TECHNICAL BULLETIN
Bell Helicopter

No. 212-09-210

MODEL AFFECTED: 212

SUBJECT: TAIL ROTOR GEARBOX EXCLUDER HOUSING
LEAK: PREVENTION OF

Figure 1

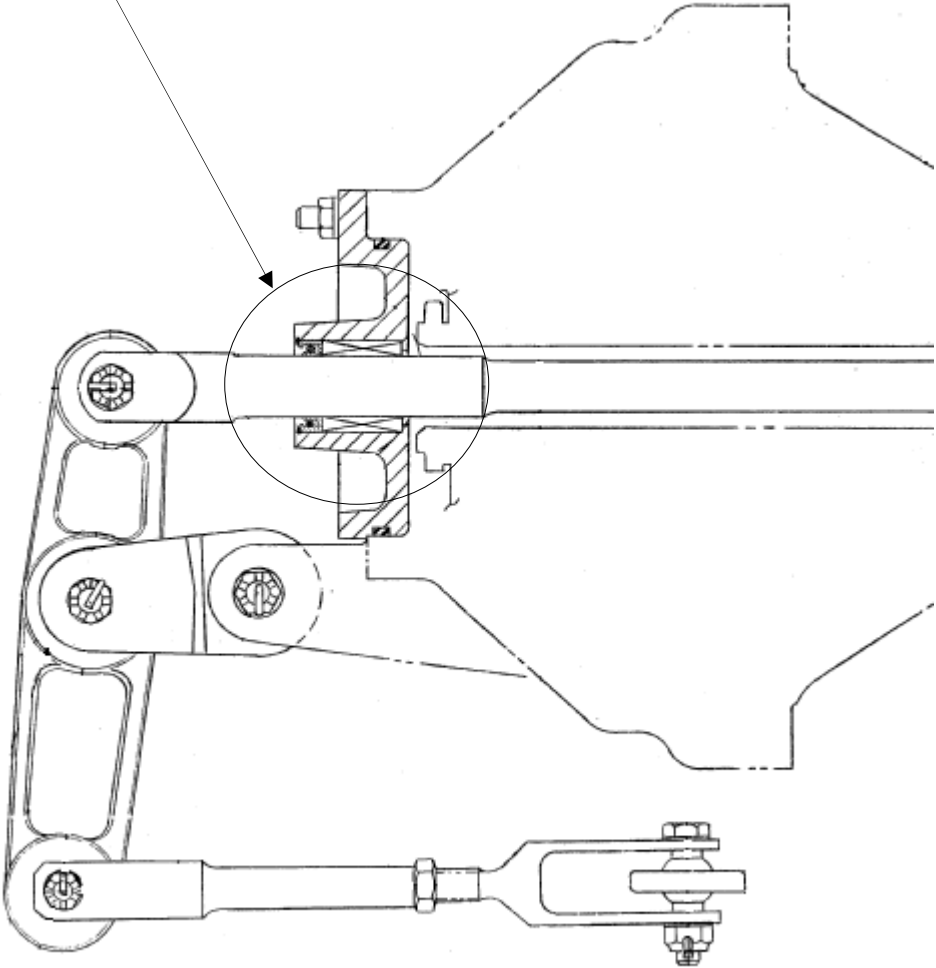
1. Make helicopter ready for maintenance.
2. Refer to Figures 1 and 2. Remove retaining ring (1) and extract excluder housing (2) by applying pressure on the tail rotor controls from full right pedal to full left. (IF excluder and packing need to be replaced refer to BHT-212-MM for disassembly instructions).
3. Using a clean cloth dampened with acetone (C-316) clean inside diameter of pitch change housing (3) where excluder housing (2) will be installed.
4. Using a clean cloth clean outside diameter of excluder housing (2) with acetone (C-316) and coat with sealant (C-328).
5. Install excluder housing (2) in pitch change housing (3).
6. Using a clean cloth dampened with acetone (C-316) remove excessive sealant and reinstall retaining ring (1).
7. Make an entry in helicopter historical records indicating compliance with this technical bulletin.

Figure 2

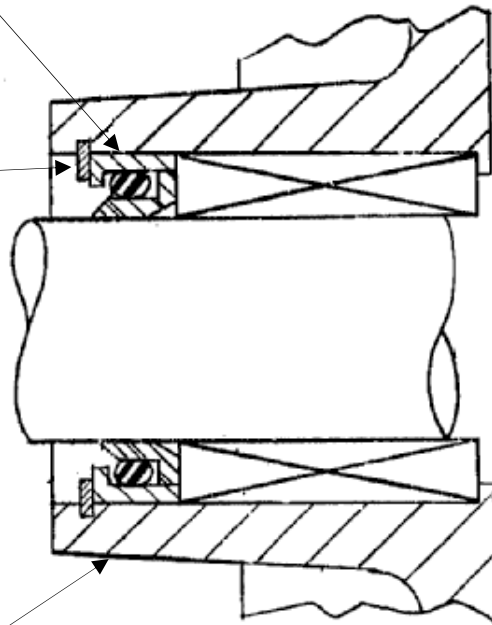
Refer to
Figure 2
